Project: 20-15092 WILCO ANNEX - GC
151 WILCO WAY
GEORGETOWN, TX

Change Order: 15
Date: 8/9/2018
Architect's Project:

The Contract is changed as follows:
Misc Subcontractor Change Orders

RE: Williamson Co. Annex
Shade J-Box locations

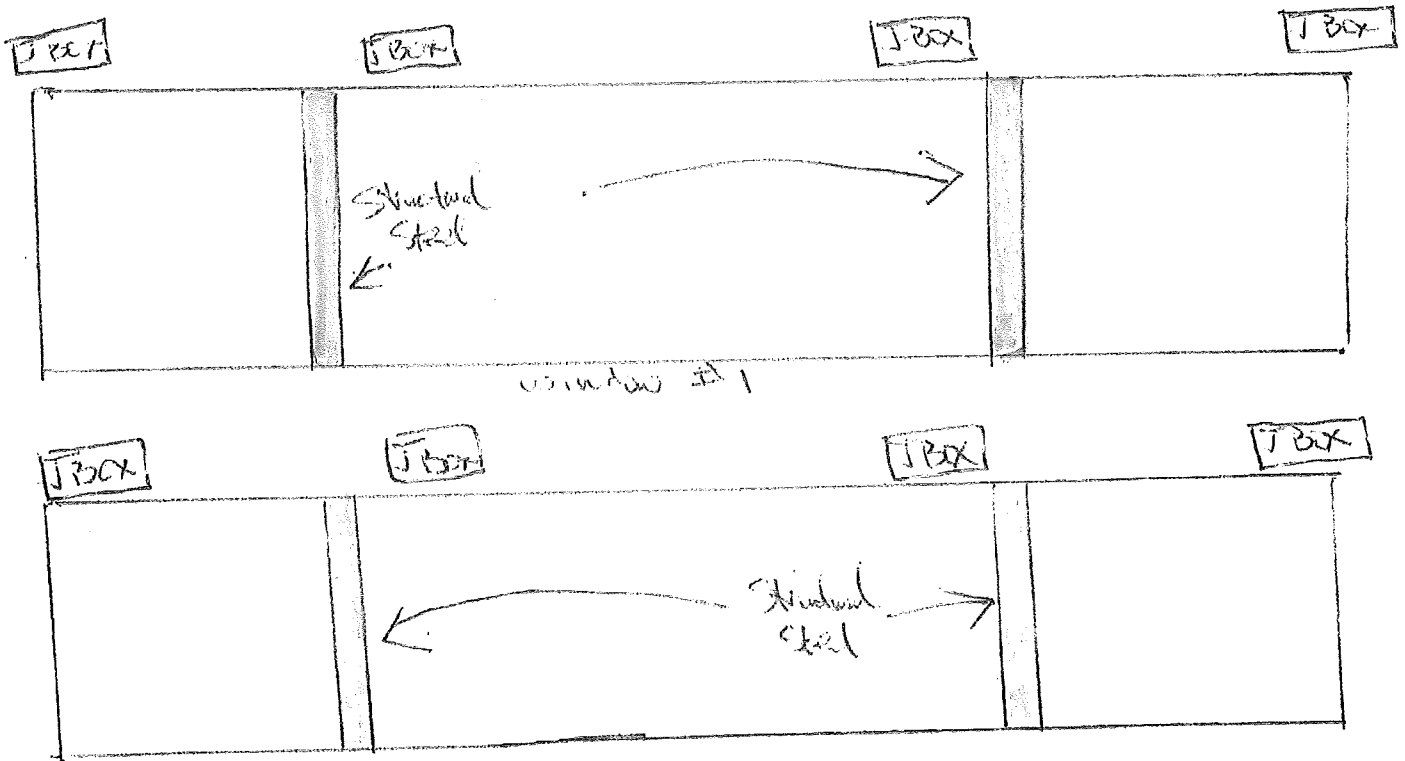
Here is our sketches for the J-Box locations for the motorized shades. Per your directive, we are showing each room.

There are a total of 4 J-Boxes per run of windows (2 runs per room) = 8 ea J-Boxes total per room.

The J-Boxes need to be within 5-8' of motor locations.

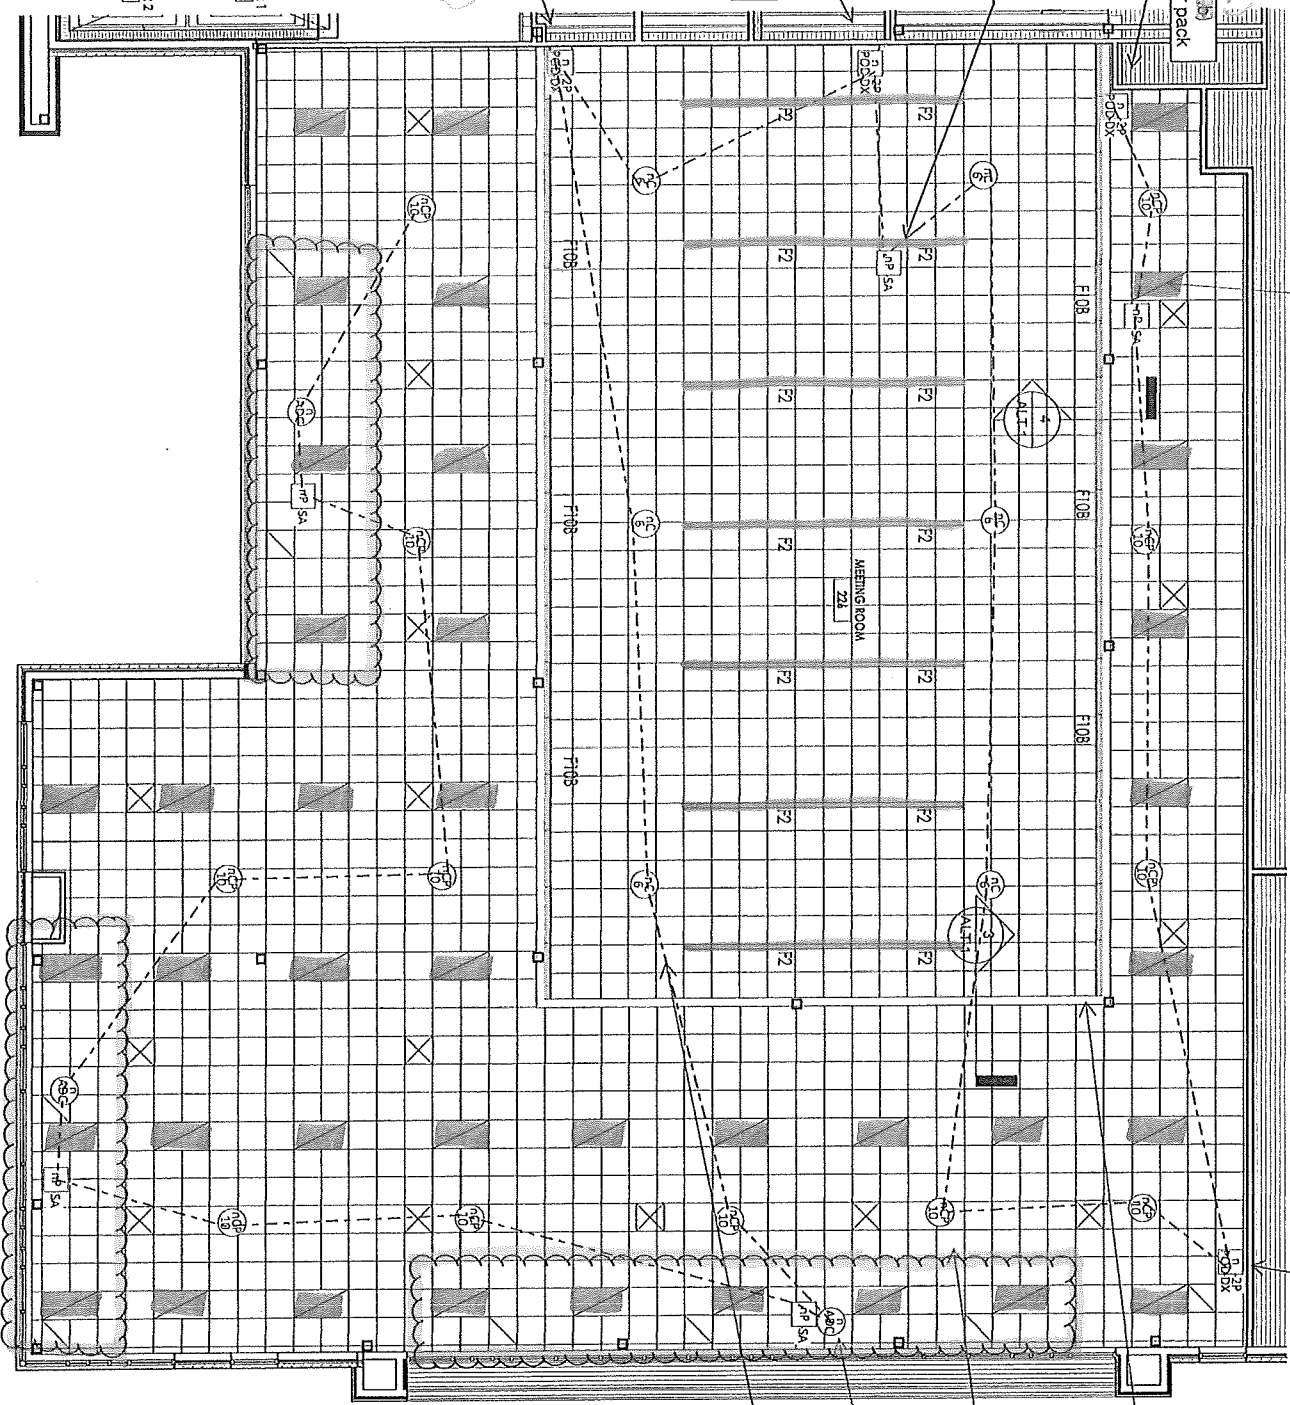
- 1 We would like to verify the lighting controls for meeting rm 226.
1. Will the F2 and F10B fixtures in the hard ceiling be controlled together on zone B?
 2. Will all 2x4's be controlled on Zone A?
 3. Please verify switch locations are correct?
- Please advise/confirm.

Reference attached sketch for zoning and lighting control requirements.

all 2x4's assumed zone A

switch Q2 (a,b) below power pack

F2 and F10B uned zone B

daylight zone power pack and sensor for zone a typ. of 3 areas

DATE: 6/28/2018
ADP JOB #: 300757
JOB NAME: WILCO
REF #: ADD BIPASS DR. JP203A

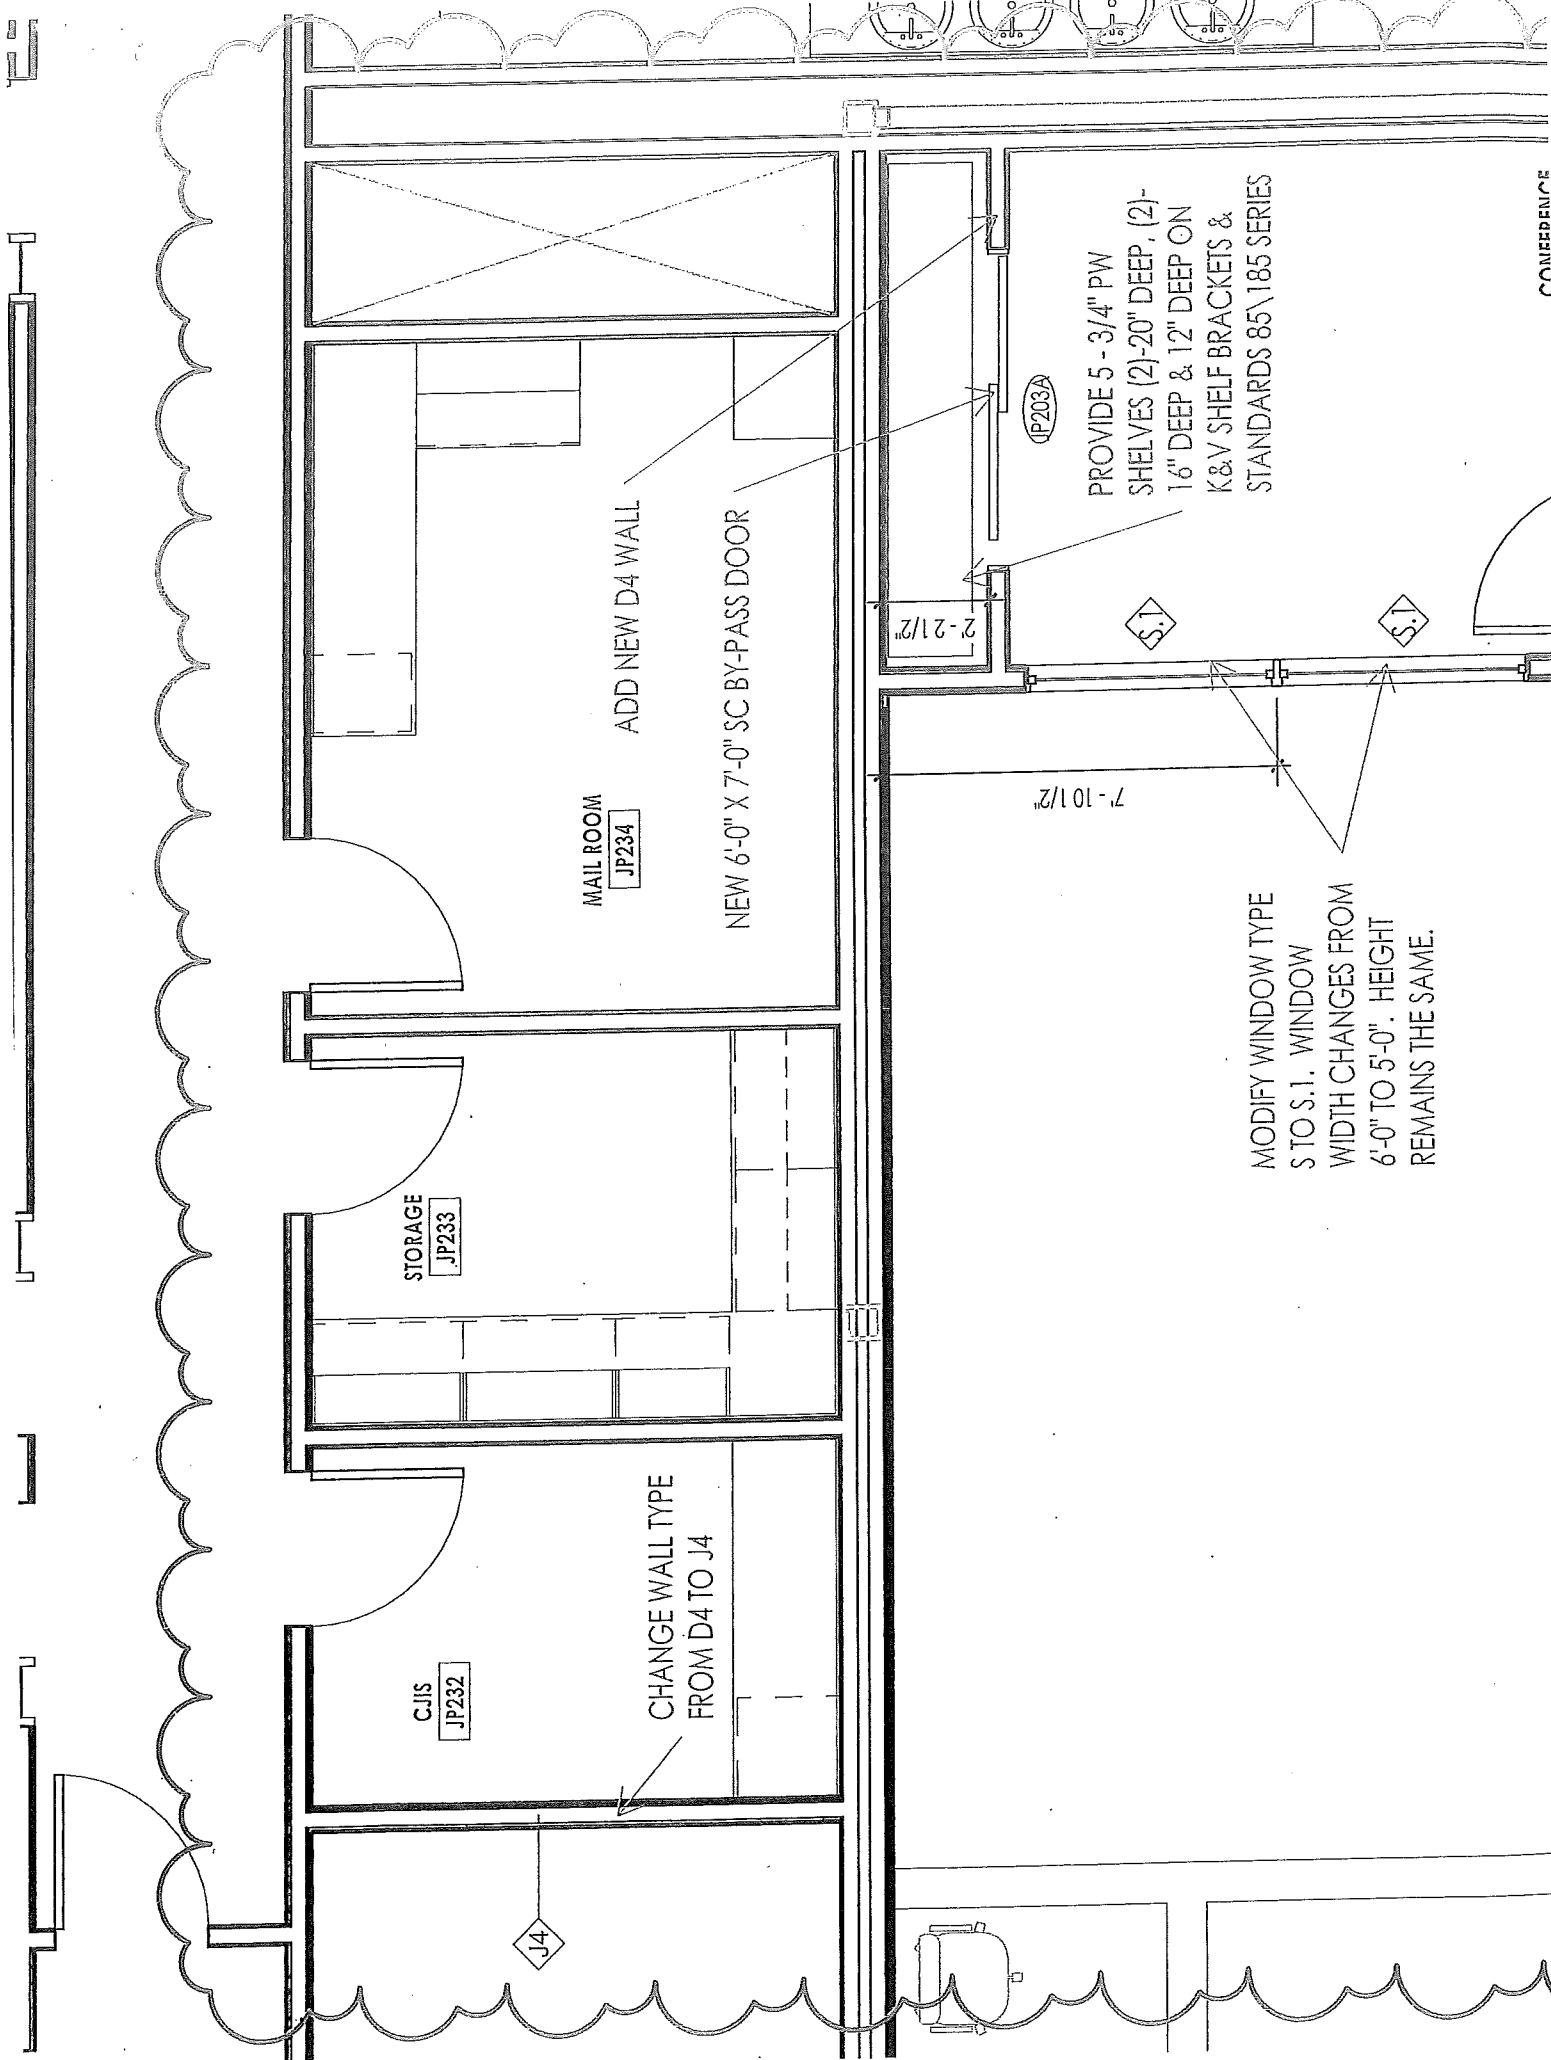
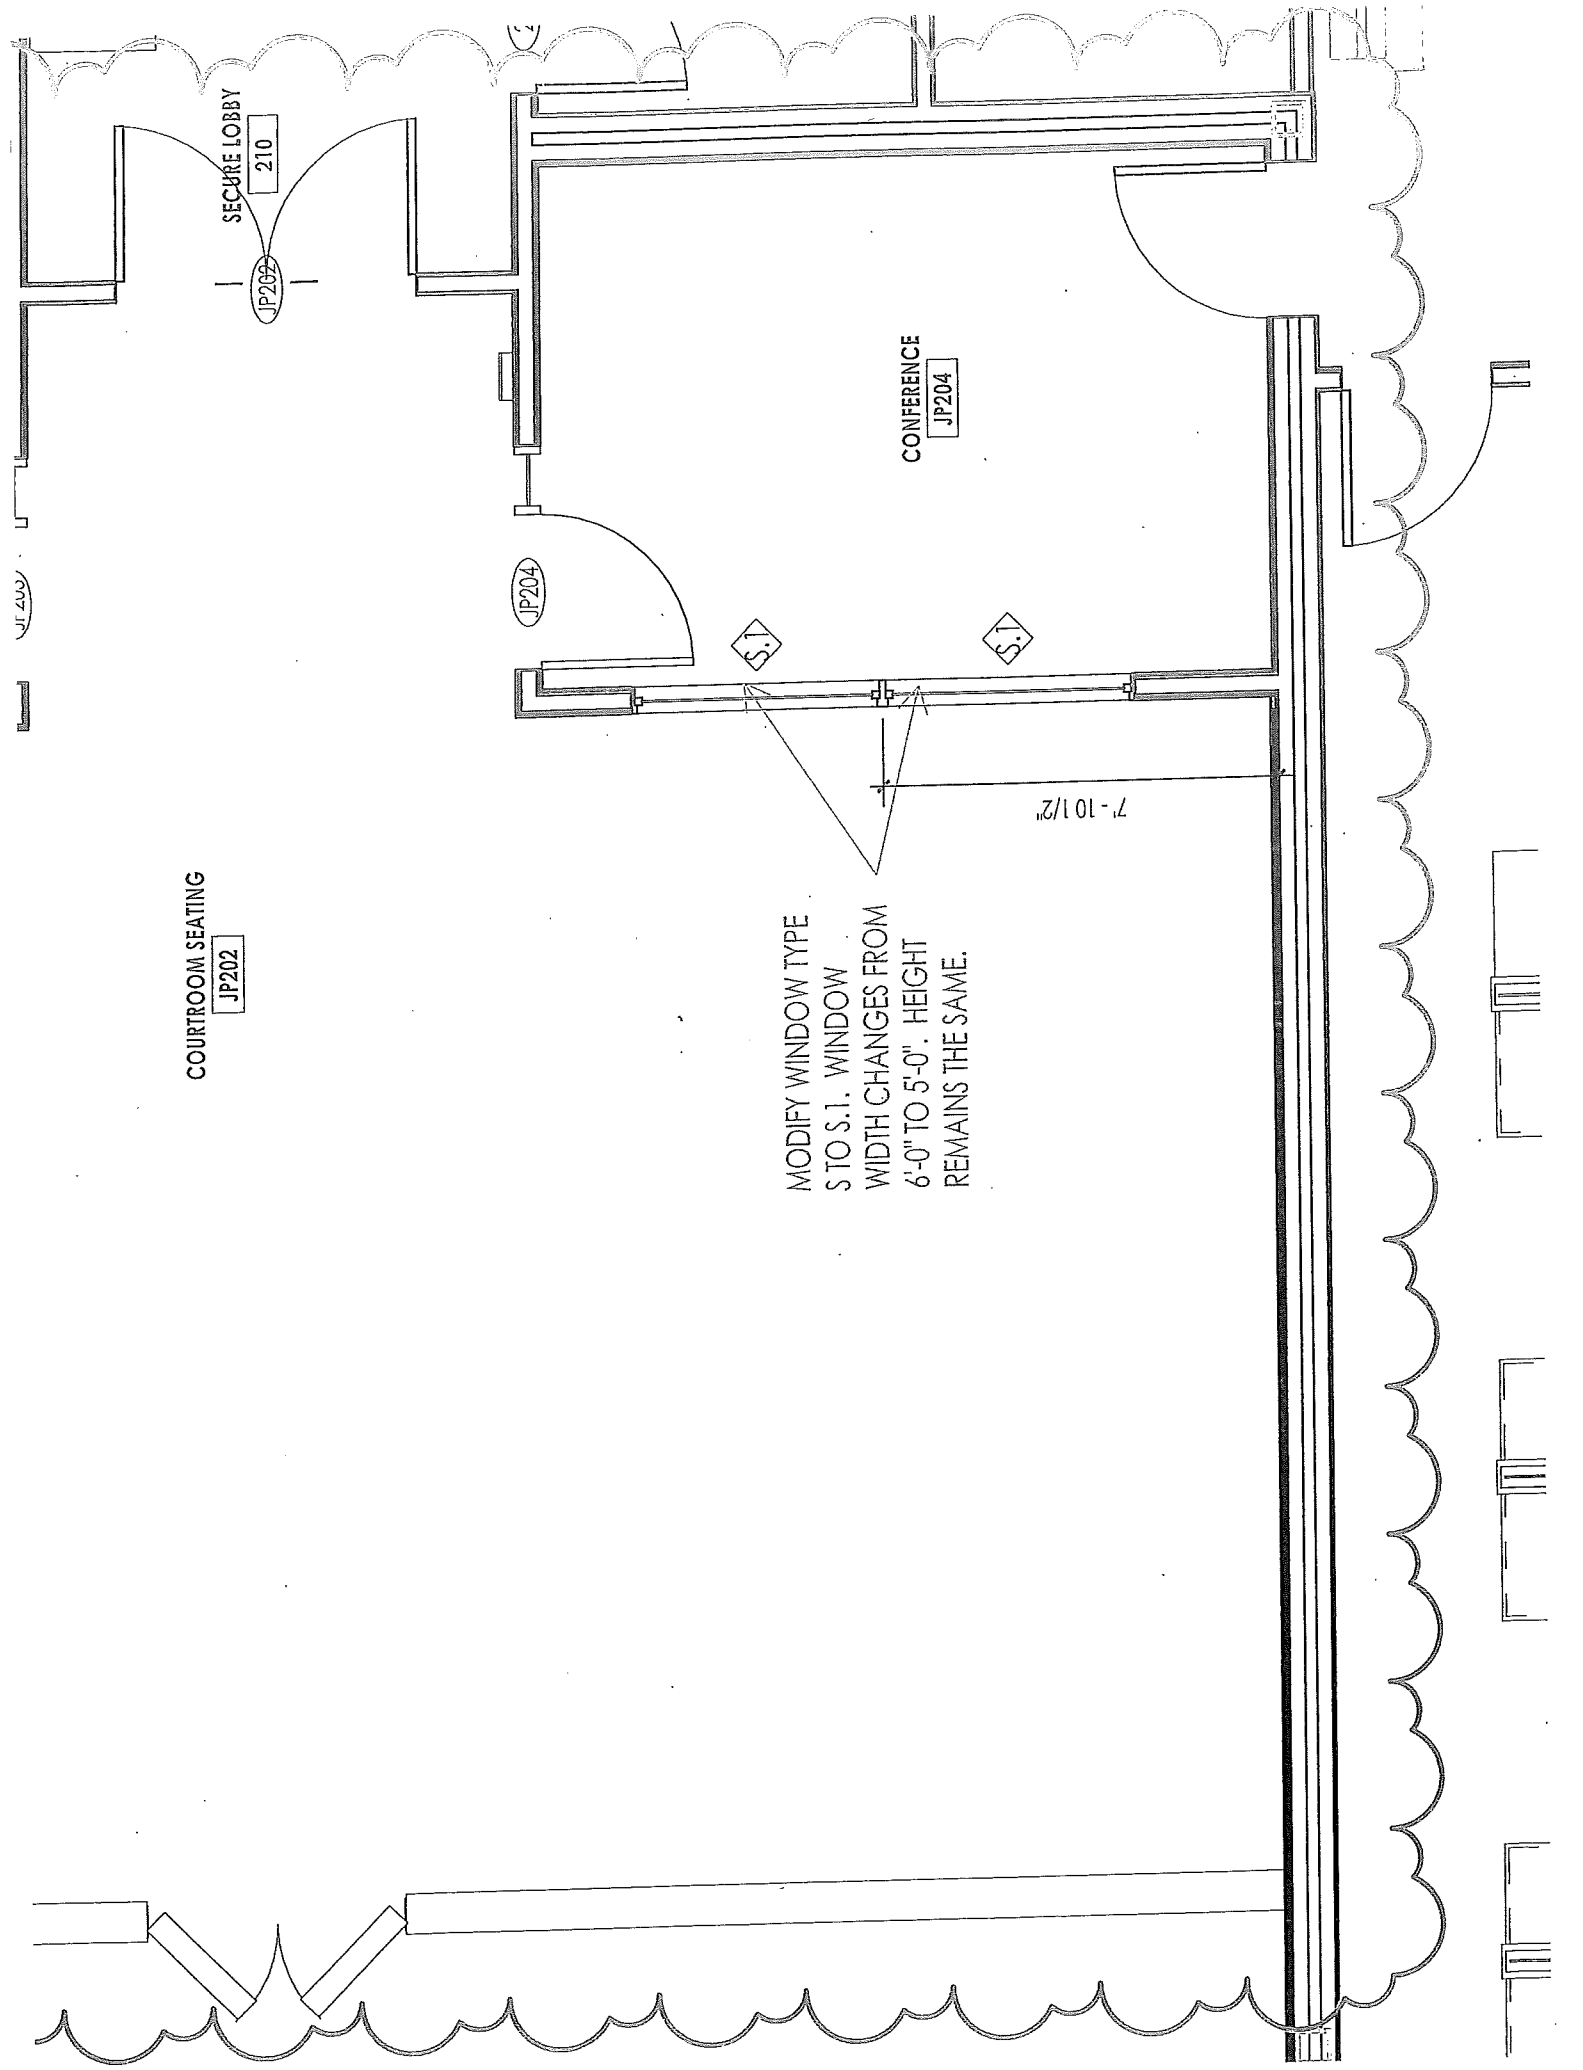
MODIFY WINDOW TYPE
S TO S.I. WINDOW
WIDTH CHANGES FROM
6'-0" TO 5'-0". HEIGHT
REMAINS THE SAME.
